RE: Federal Cell Facility Application Request for Information

Federal Cell Application Review

Request for Information or Updates to the Application (RFI)

Appendix B: Federal Cell Facility Engineering Drawings

DATE BY DESCRIPTION OF CHANGE

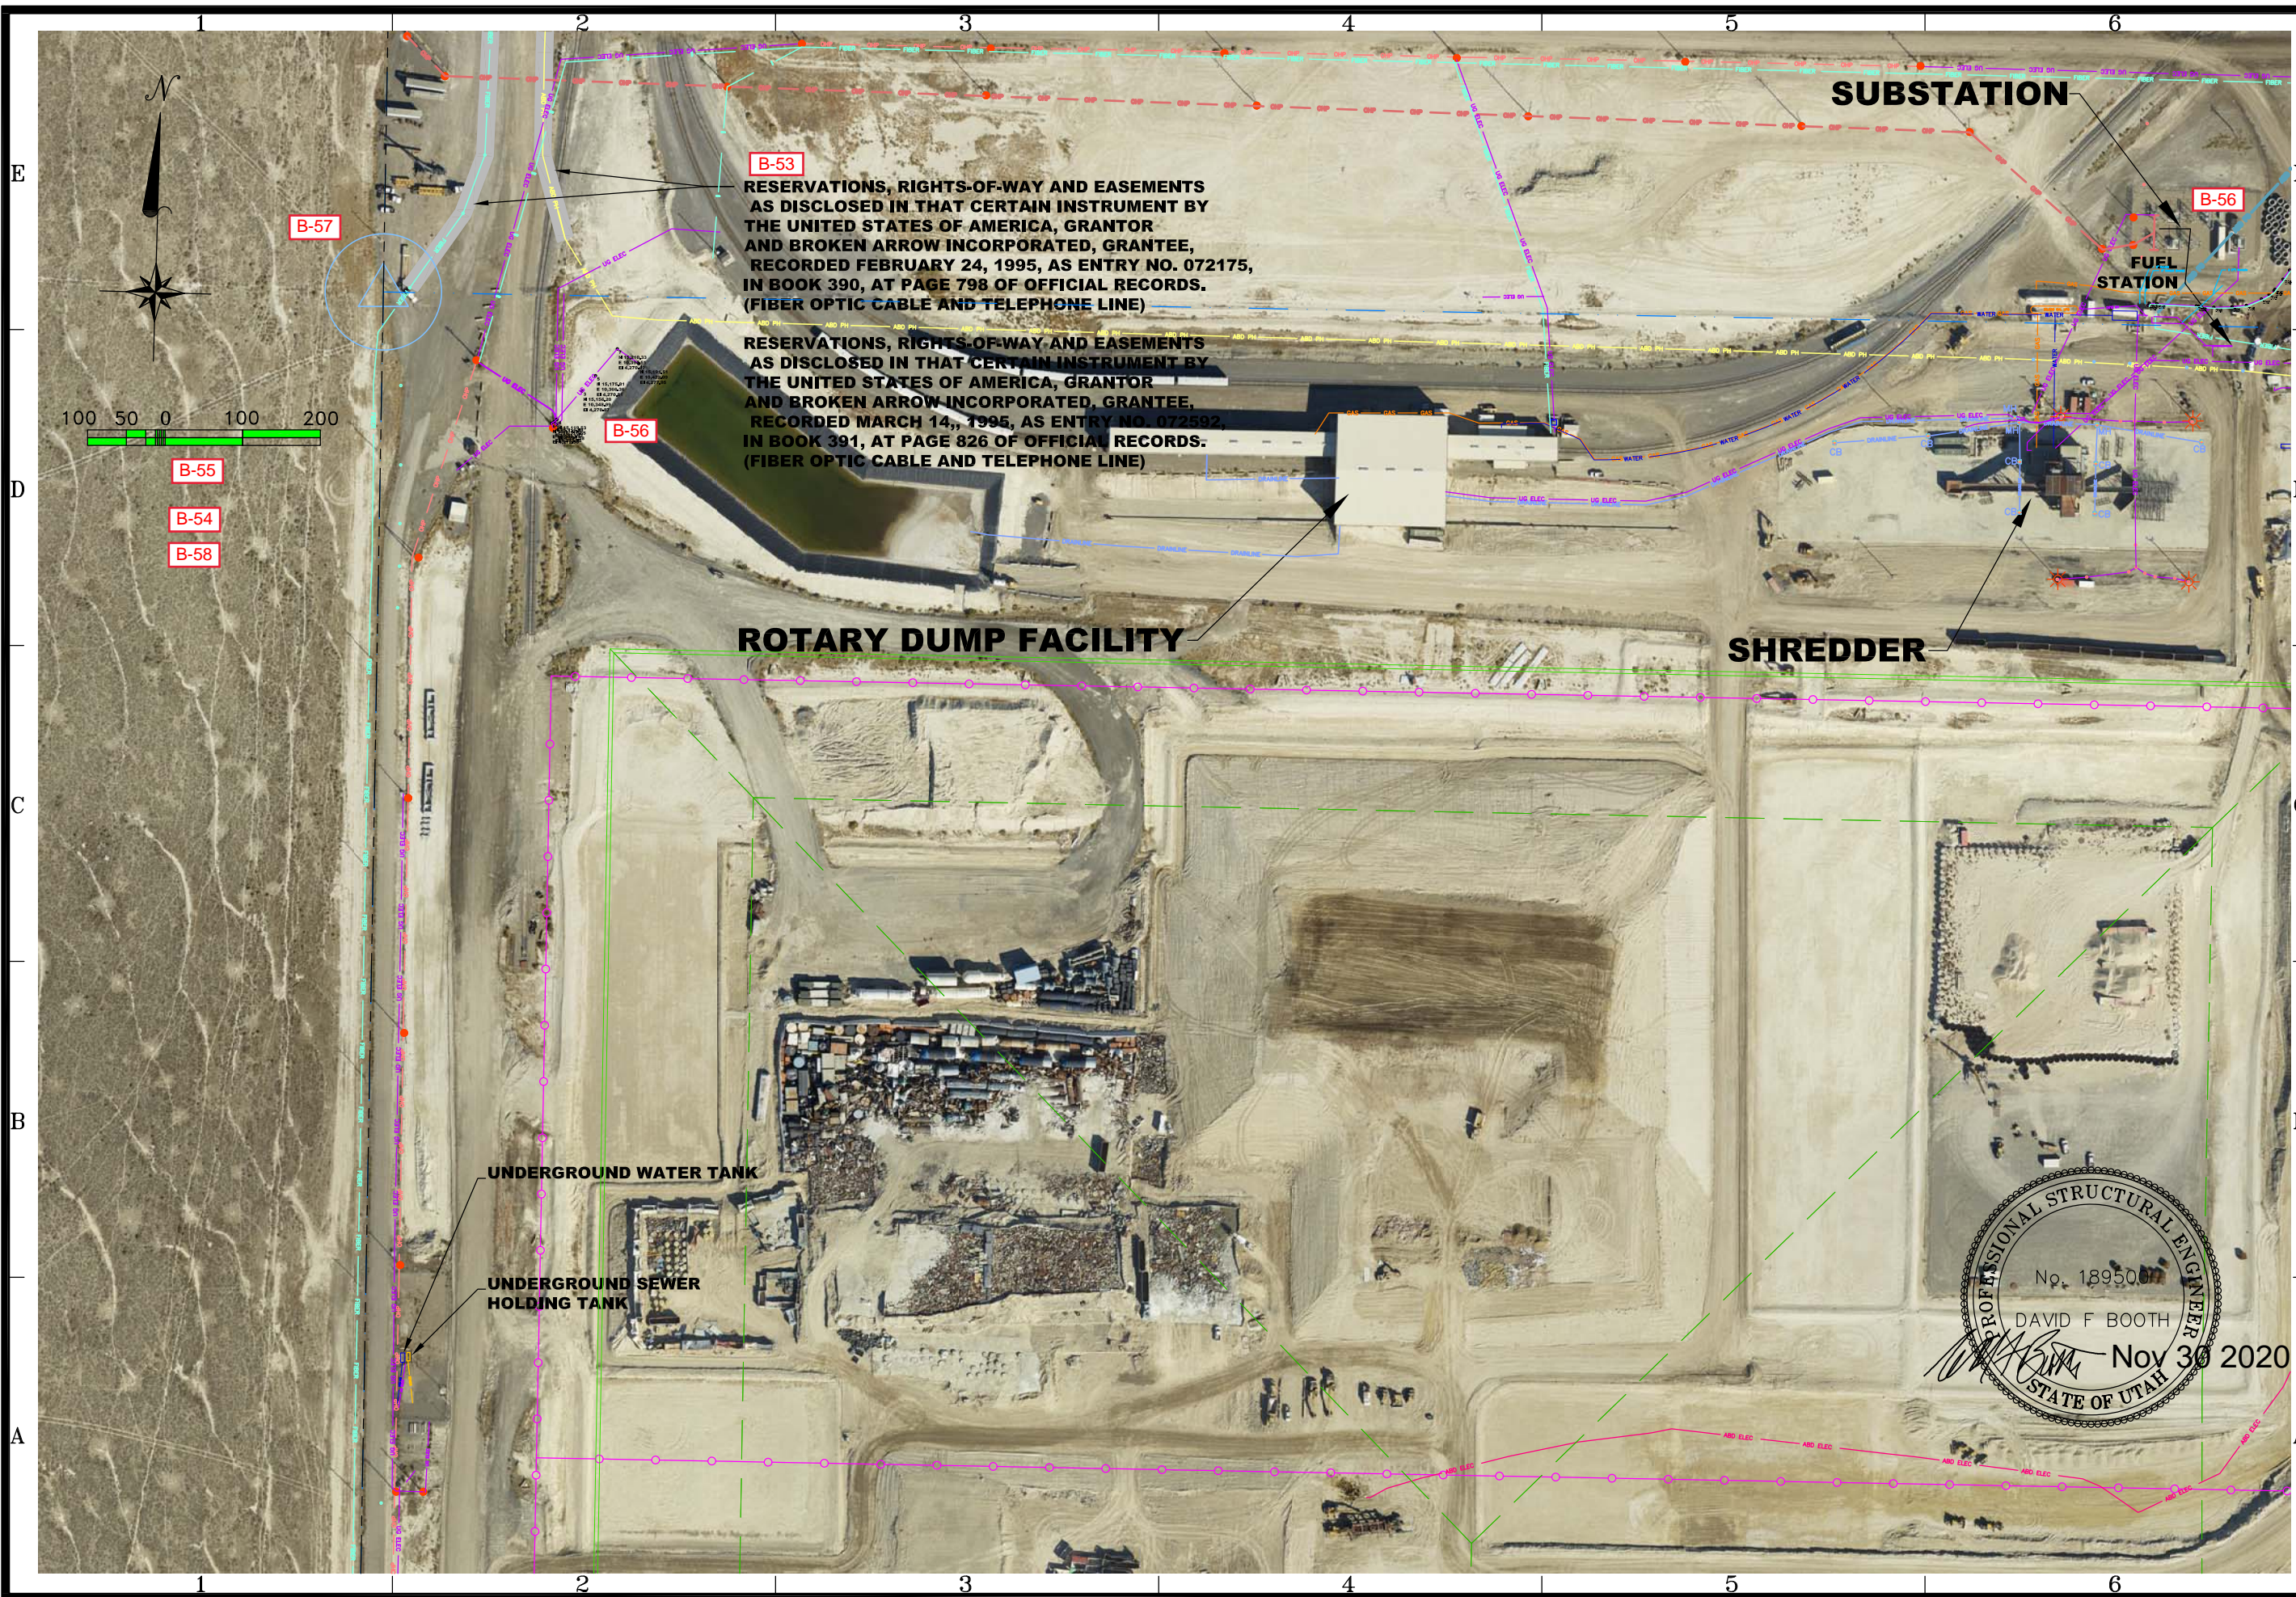
▪ **B-57**
